FINAL ENVIRONMENTAL IMPACT REPORT FOR THE LOS ANGELES AERIAL RAPID TRANSIT PROJECT LOS ANGELES, CALIFORNIA

VOLUME IV

- 6.0 RESPONSES TO COMMENTS**
 - 6.3 Responses to Comments
 - 6.3.3 Responses to Public/Individual Comment Letters [P601-P751]

Figure 3: Area of Potential Impact (API). Base image courtesy of Google Maps.

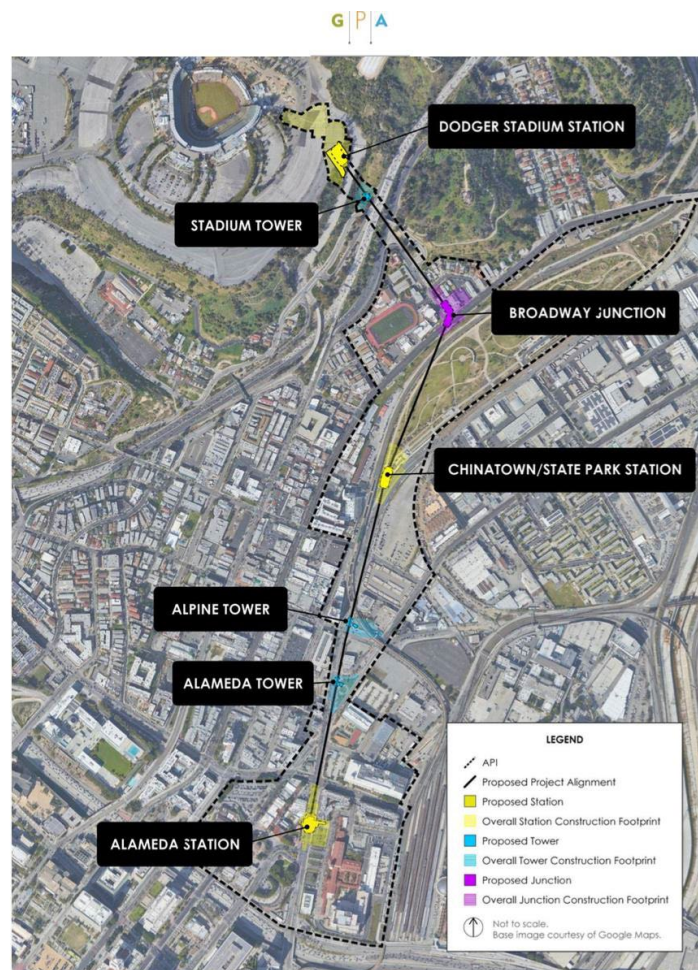
Comment P701-5 As noted in the Historic Resources Technical Report included in Appendix G of the DEIR, there are 12 previously-identified historical resources within the proposed Project’s API. Two of the historical resources are historic districts with contributing resources located within the API. In addition, the historic resource consultants identified the El Grito mural as eligible for listing in the National Register of Historic Places (National Register).

The next Figure, reproduced from DEIR Appendix G, shows the Project alignment and API defined for purposes of analyzing the historic resource impacts of the Project.

Section 2.5.1 of Section 2.0, Project Description, of the Draft EIR details the proposed Project’s alignment, noting that the proposed Project alignment was chosen as it maximizes alignment along the public ROW and publicly owned property and minimizes aerial rights over private properties, taking into account existing and future adjacent land uses. Figure 2-8 in Section 2.0, Project Description, shows the portions of the proposed alignment over public ROW and publicly owned property and the portions of the proposed alignment over private property, which are described more specifically in Appendix Q, Proposed Alignment Plan and Profile, of the Draft EIR. The Draft EIR does not need to be revised to include a map of the land ownership within the API.

This comment also assumes that the proposed Project will involve the taking of private land. As described throughout the Draft EIR, the proposed Project would require aerial easements for certain properties along the proposed Project (see Sections 2.5 of Section 2.0, Project Description, and 3.11.1, Figure 6-12 of Section 3.11, Land Use and Planning). How the Project Sponsor acquires the aerial rights for the proposed Project is beyond the scope of the Draft EIR. CEQA does not require extensive detail beyond that needed for evaluation and review of the proposed Project’s environmental impact. (See, e.g., CEQA Guidelines § 15124.) The Draft EIR provided sufficient information in order for the public and decision makers to meaningfully evaluate the proposed Project’s potential environmental impacts. CEQA does not require “a lead agency to conduct every test or perform all research, study, and experimentation recommended or demanded by commenters” and lead agencies are not required to “provide all information requested by reviewers.” (*Id.*, § 15204.) Further, to the extent eminent domain is used to acquire property rights necessary for operation of the proposed Project, the exercise of eminent domain by any public agency would be subject to a separate process as required by California law. Refer to Response P701-7 for further discussion of Metro’s eminent domain authority.

Image from DEIR Appendix C – Visual Impact Analysis / Lighting Design

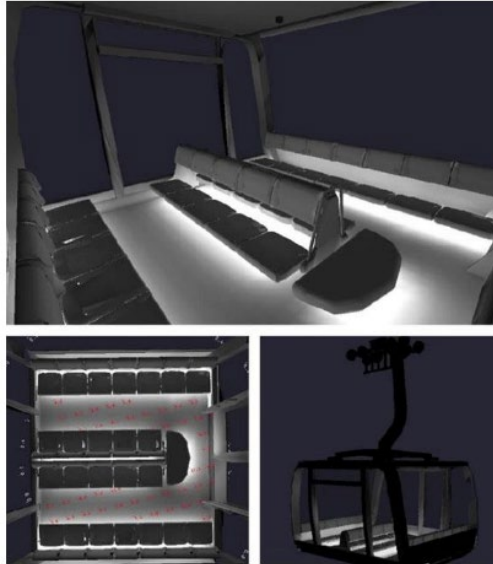
There needs to be greater consideration for security of the gondola infrastructure to prevent unintended uses of the system. If the opening of the Sixth Street Viaduct is any indication, the absence of ladders will not prevent people from climbing the towers and stations. If a person is able to get access to the Dodger Stadium parking lot or the Broadway Junction, would they be able to use The Gondola as a zip line?

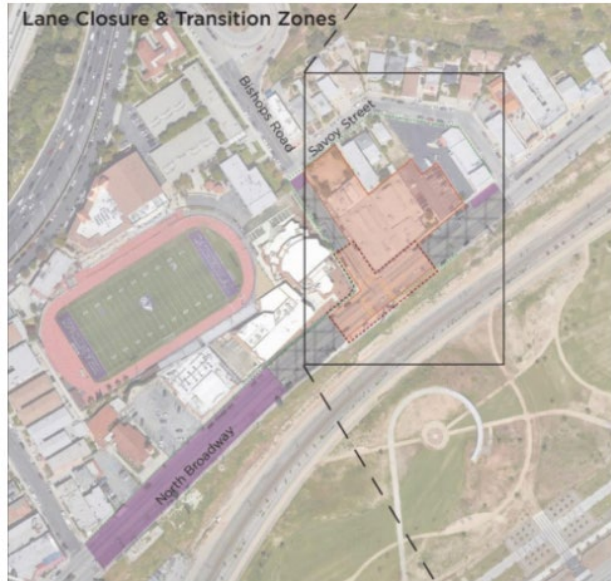
Comment P702-85 The construction documents for the Broadway Junction do not show where the drive motor would be located. Is that at ground level?

Response P702-85 Refer to Responses P702--24 through P702-27 for discussion of the drive motor at the Broadway Junction.

Close Up of DEIR Image Showing the Base of the Alpine Tower

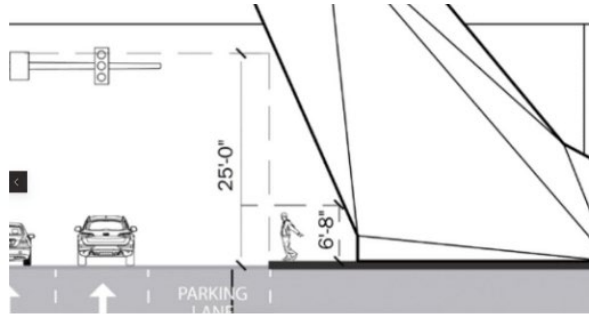
Alpine Tower requires that a traffic lane on Alameda Street be sacrificed in order to maintain a sidewalk around the base of the 200 ft tall gondola tower, which sits at the edge of the existing curb/sidewalk. The tower, however, still crowds the sidewalk by leaning into the airspace above the sidewalk. This looks like a very unpleasant pedestrian experience. The sidewalk needs to be wider, but this project is already taking space on our streets that could be used for wider sidewalks, bus lanes, and bike lanes. What is the impact of this tower, the space it needs on the street, to planned improvements to Alameda Street? Does this mean a protected bicycle lane or a bus lane can never be on this side of Alameda Street?

Response P702-88 The Alpine Tower would not require that a traffic lane on Alameda Street be eliminated. A comparison of the Alpine Tower | Existing diagram on page 25 and the Alpine Tower | Build-Out diagram on page 31 in Appendix B, Construction Assumptions, Exhibit 1, Overview of Construction Phasing and Area Conditions, of the Draft EIR shows that the same number of travel lanes will be provided on Alameda Street after construction of the Alpine Tower is complete as there are under existing conditions.

Regarding the sidewalk width, the sidewalk adjacent to the proposed Alpine Tower location is approximately 10 feet in width. As noted on page 3.17-9 of Section 3.17, Transportation, of the Draft EIR, Alameda Street is classified as an Avenue I and is also designated as part of the Bicycle Enhanced Network in the City of Los Angeles Mobility Plan. Avenue I facilities have a desired right-of-way width of 100 feet. The existing right-of-way width of this portion of Alameda Street is greater than 100 feet. As such, the tower should not conflict with future City plans.

DEIR Image of Broadway Junction with Notes

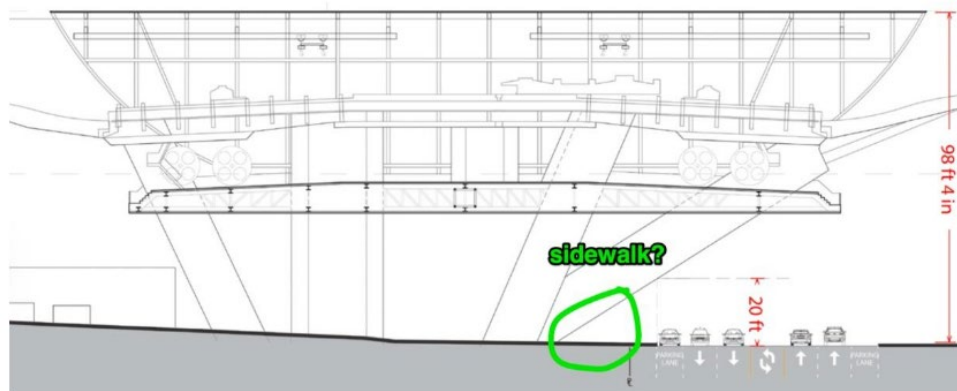
Comment P702-89 Broadway Junction: More information is needed on the sidewalks around the Broadway Junction, especially at the area indicated in the image below. How high is the overhead clearance of the support column, how wide is the usable space of the sidewalk? There is a bust stop located at this location on Broadway. Will this interfere with a bust stop shelter? How wide will the sidewalk be along Bishop's Road? Currently, there is no sidewalk, even though it is an official route to Dodger Stadium.

Photo – Popular Hill at LA State Historic Park

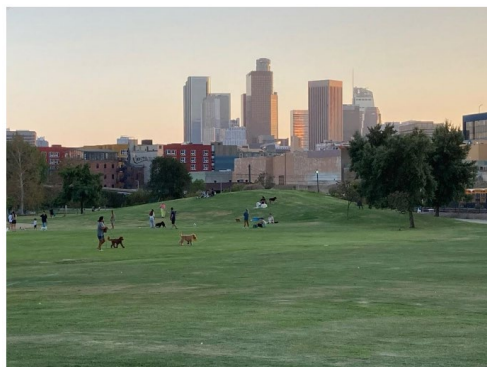
Comment P702-114 LA ART states repeatedly in the DEIR that The Gondola flies over the “western edge” of the park, but that’s completely false. It travels over the heart of the park, over a very popular hill where people play and gather. Kids roll down the hill like logs. People sit and dogs play with each other. How are you supposed to relax and enjoy yourself if every 13 to 25 seconds, there’s a massive cabin full of people flying less than 26 feet over you with people literally looking down on you?

The LA ART Gondola would fly 26ft over this hill.

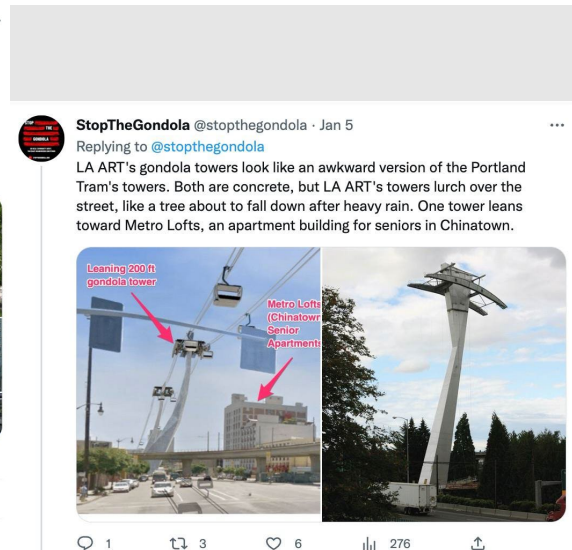
Will the LA ART Gondola bring more rideshare traffic into my neighborhood, which is close to the Downtown Gate? Residents in some neighborhoods around Dodger Stadium have reported rideshare drivers using their neighborhoods as waiting areas, and noted that the rideshare companies actually encourage it by paying them a bonus. Will this happen in my neighborhood? There needs to be mitigation for this likely impact. This is just one example of how this gondola project would likely bring more traffic, congestion, and pollution into our neighborhoods, not less.

Response P709-21 Traffic congestion is not required to be analyzed under CEQA in the Draft EIR following the implementation of Senate Bill 743, which designated “vehicle miles traveled” as the method for assessing transportation impacts on the environment for CEQA projects. The proposed Project is not expected to increase the number of pedestrians or vehicles accessing Dodger Stadium. The vast majority of visitors drive their personal vehicles to access Dodger Stadium. These vehicles create congestion on the surface streets leading up to and around Dodger Stadium, including Sunset Boulevard/Cesar E. Chavez from LAUS and throughout the surrounding communities. Given the capacity of the proposed Project’s system, approximately 20 percent of the fans could take aerial transit connected to Metro’s regional transit system. This would reduce vehicular congestion in and around Dodger Stadium, on neighborhood streets, arterial roadways, and freeways during game and special event days. As such, the number of vehicles approaching the Downtown Gate would likely decrease, rather than increase. Within the Dodger Stadium parking lot, people walking between the

stadium to the Dodger Stadium Station would be managed via traffic control officers pre- and post-game and would not affect circulation outside the Downtown Gate.

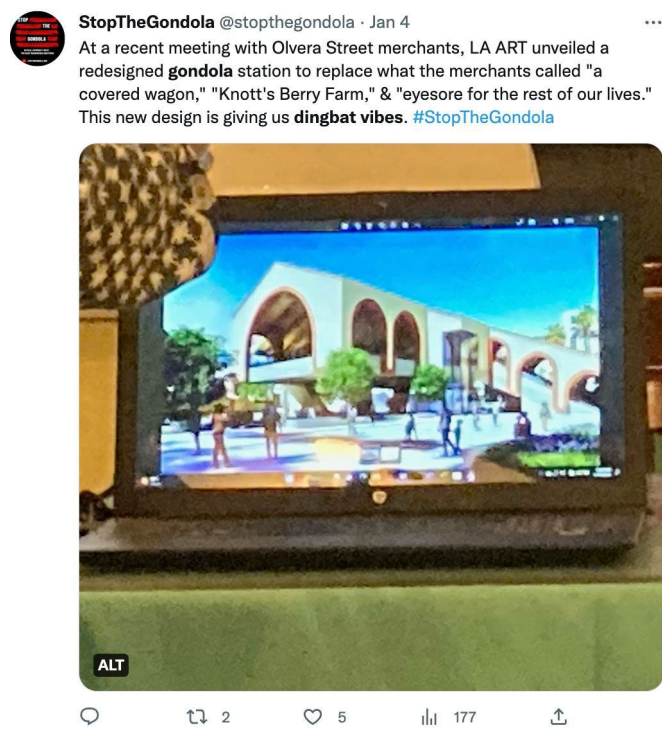
Gondola station and designs should not be cookie cutter or generic. This would be built at the birthplace of our city. LA ART claims this will be iconic, but how is the design iconic? There is no sense of place. Stations look generic and towers are a stark gray concrete. We don't need more gray concrete in our historic neighborhoods. The cabins also appear to be standard cabins.

Response P709-22 Refer to Topical Response C, Project Features, for discussion of how the proposed Project’s design takes cues from the immediate neighborhood culture, including how each component of the proposed Project would be designed to complement and reflect the unique character of the surrounding area. The Project Sponsor would utilize local artists for site specific artwork at each station reflective of the unique neighborhood culture, and would create numerous opportunities to collaborate with
